# Access Compliance Report

## Public Rights-of-Way

Intersection ID: 3220	Main Street: MEADOW_POST_LN	Cross Street: OLD_TIMBER_RD	Location: NW
ADA ID: 52232AFBFCD3	Ramp Type: BlendTrans1	Initial Pass/Fail: Fail	Overall Compliance: No
		Severity Score: 1.25

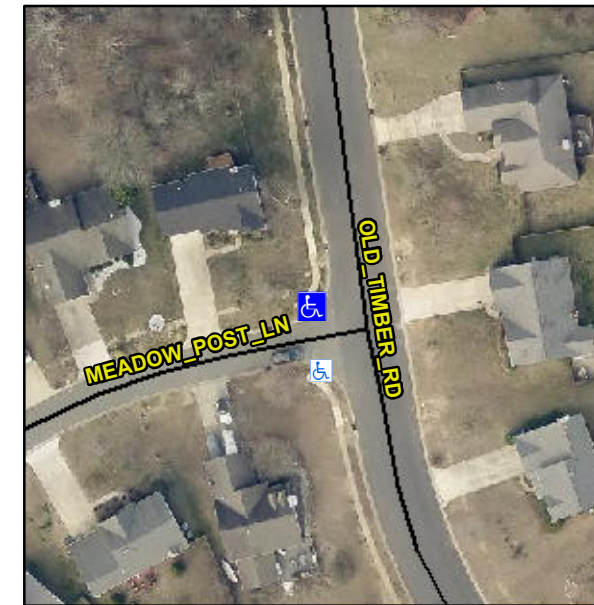
**Not Found, R304.5.3**

**Remove & Replace Curb Ramp With Two New Directional Ramps or Equivalent.**
